**Development Adjustments  
Commission Meeting**

# DEVELOPMENT ADJUSTMENTS COMMISSION AGENDA

**DAC2023-029    2200 Tanglewood Drive – Valley Lo Pickleball Courts**  
**(Public Hearing)**

Proposal:            Recommendation to Board of Trustees

Landscape Plan Enlargement

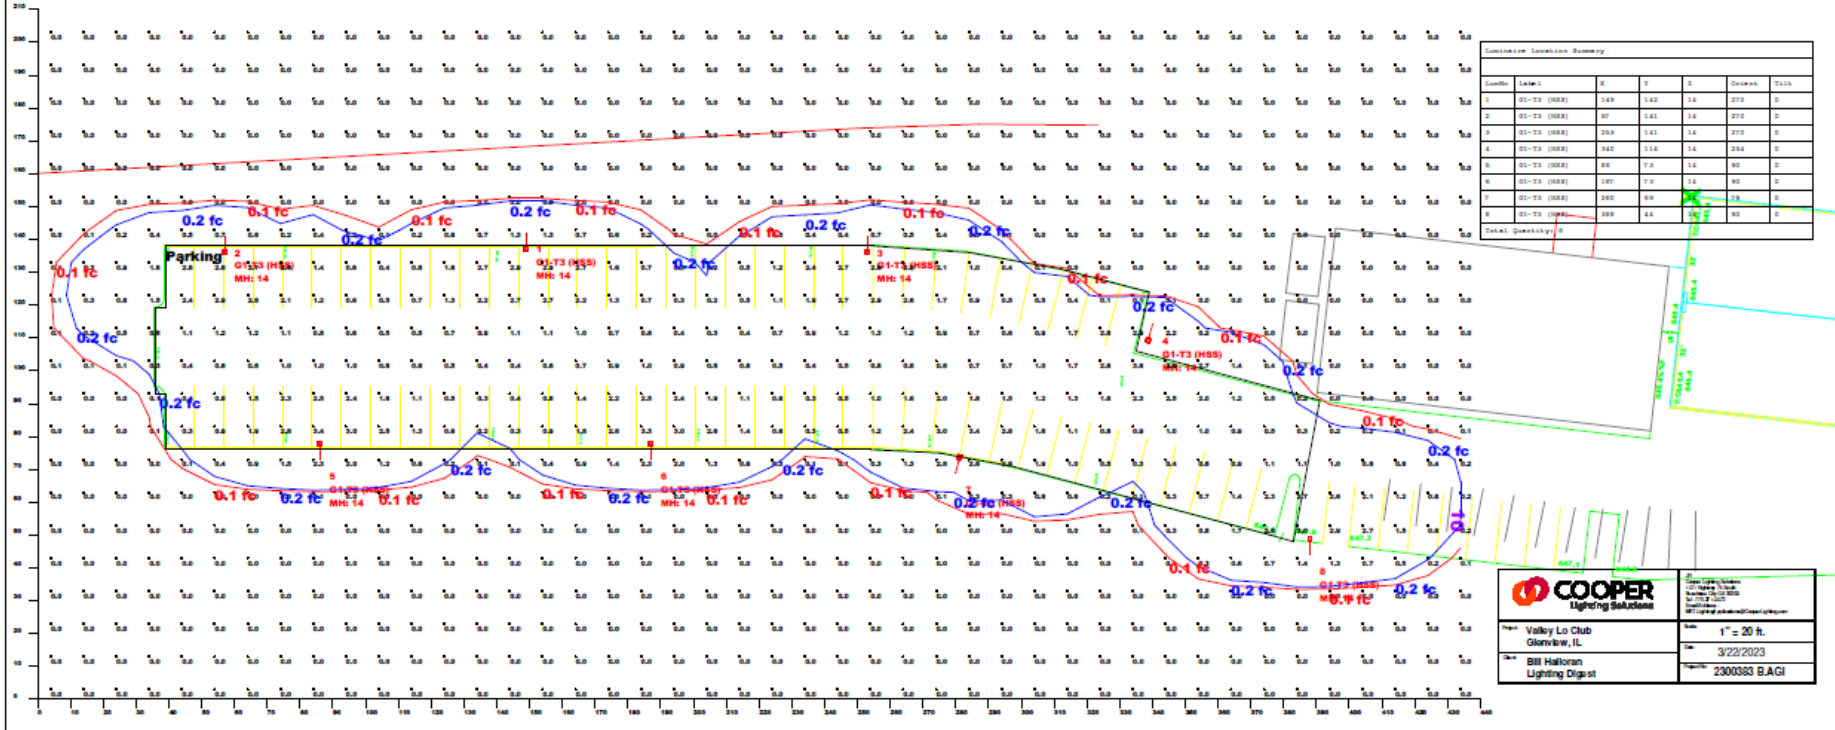
**Fencing:** The plan specifies the installation of a green 6', rather than 4', chain link fence with green, rather than black, privacy slats for the east side of the new parking lot. The fence selected has a wind load and privacy factor of approximately 75%, which combined with the dense landscape should reduce and or eliminate light levels seen across the lake.

**Fence Extension:** To preserve the natural topography and vegetation, we will not be extending the chain link fence north of the new lot. Doing so would require the removal of several mature trees. In addition, the parking spaces in this location have been in use for more than 40 years.

- A. "Landscape Plan Enlargement" (Sheet L-2); and
  - B. "General Notes and Planting Details" (Sheet L-3).
5. **Preliminary Lighting** approval for the Subject Property in accordance with the following:

# Sport Court Photometrics

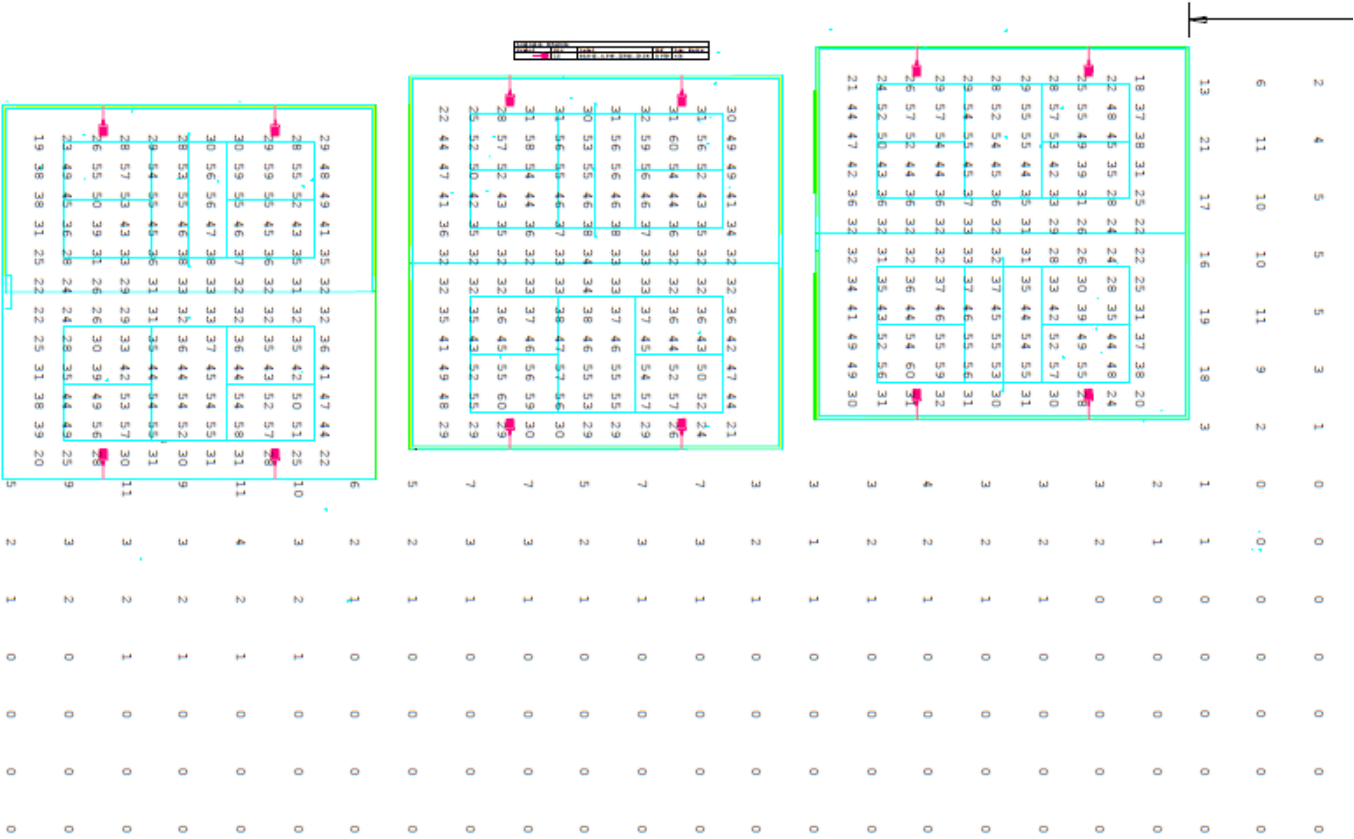
**Court Lights:** To reduce the light glare, we are presenting a new lighting plan, which includes (12) 20-foot light poles with no-tilt 400-watt fixtures and back glare shields. The shields and no-tilt angle of the lights both were requested by the HOA. Players will have the ability to turn the lights on and off during permitted hours of play. The lights will be automatically disabled at the end of permitted play.

- C. The manufacturer's specifications for Brite Court Sports Lighting Edge Series Fixtures with Shields;
  - D. The applicant shall include all illuminated areas of the site and clarify the extents of the lighting zones noted on the photometric plan to determine whether modifications to the plan may lower the uniformity ratio; and

- E. If necessary in order to prevent light trespass and glare, the applicant shall include shields on proposed fixtures.
6. All materials presented to the Development Adjustments Commission on April 3, 2023, April 19, 2023, May 3, 2023 and May 17, 2023 and associated revisions as required by the Development Adjustment Commission and Board of Trustees.

**Figure 3 – Sound level contours around the proposed pickleball courts in full use at 10 PM**

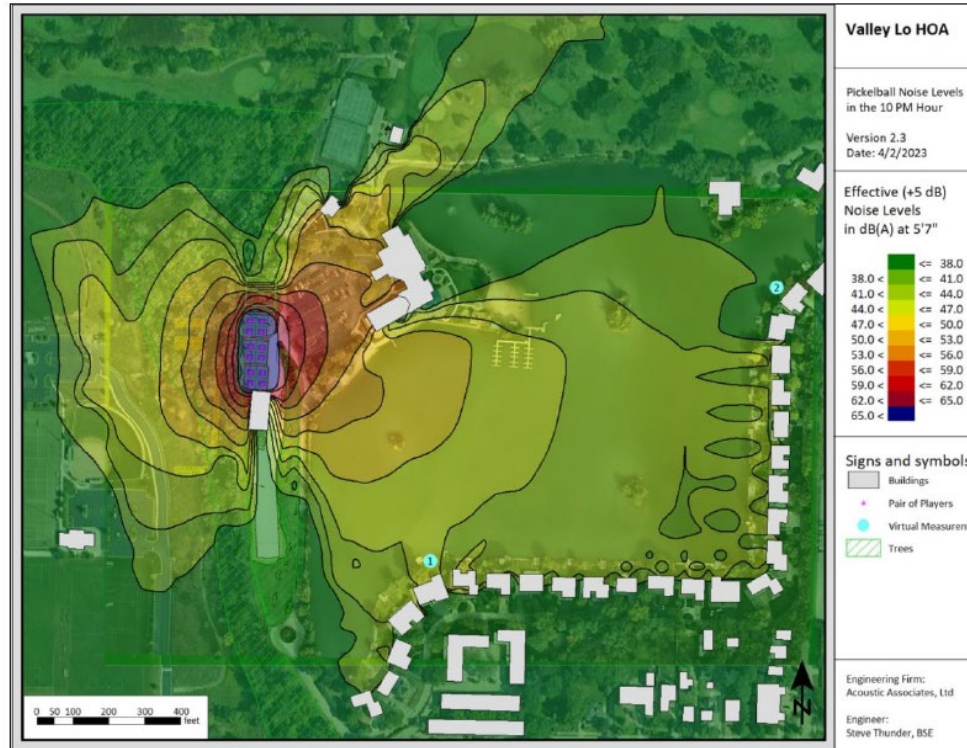
**Sound Barrier:** We agree, as requested by the VL Lake HOA, to install a sound barrier per the Acoustic Associates, Ltd. report submitted by the VL Lake HOA, dated May 3, 2023. The sound barrier (Acoustifence) would be installed on a 10-foot fence on the east fence of courts 3 and 5. According to that expert report, this modification – standing alone – “effectively reduce[s] the pickleball noise to 2dB above the ambient level, which would be considered *no impact*” even at 10 p.m.

**Additional Sound Barrier:** As noted above, the VL Lake HOA's expert study concluded that only a sound barrier on the east fence of courts 3 and 5 is necessary to bring the noise level from pickleball to a level considered “no impact” on neighbors.

- G. A fountain shall be installed on the south side of the lake to establish additional baseline ambient noise.
  - H. A 10.0 foot tall sound barrier comprised of a chain-link fence and acoustic fence panels shall be installed east of courts 3 and 5.

3 Ornamental Fence with Metal Posts - Alternate  
 SCALE: N.T.S.  
 d-fence-prefab slum\_12

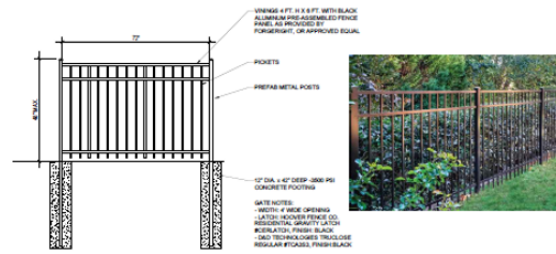
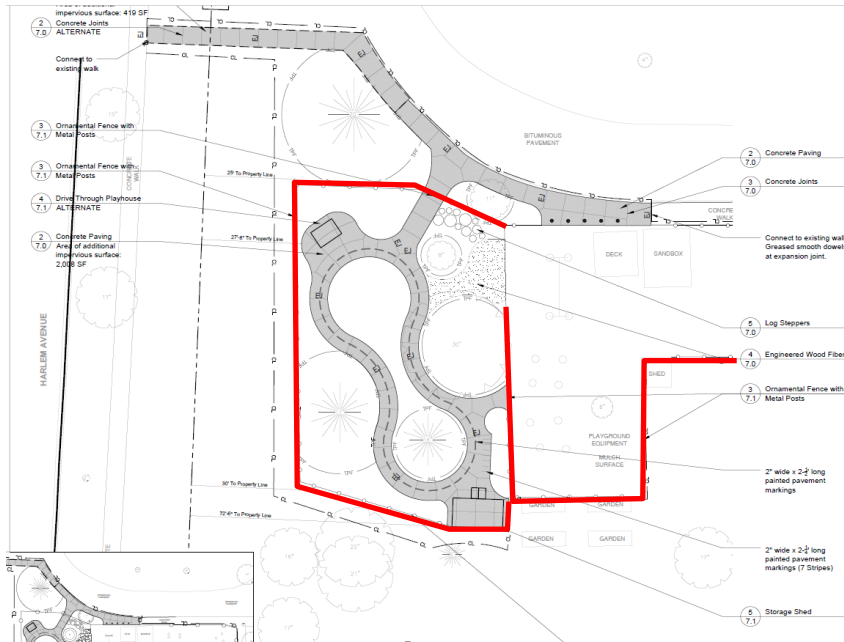
- a. Landscaping | The following comments relate to the issue of landscaping in regard to the proposed development plans:
- i. The applicant has provided a landscape plan with the location of various plantings included.
  - ii. The Development Adjustments Commission should provide feedback regarding the plant list, variety of species, and proposed design of landscaped areas.
  - iii. The applicant originally requested a variation for fence material, but that variation request has been withdrawn. A faux wrought iron fence is proposed and the material and height are acceptable per Code.
  - iv. The applicant is proposing to expand the area of new fence to include some areas of the existing playground.
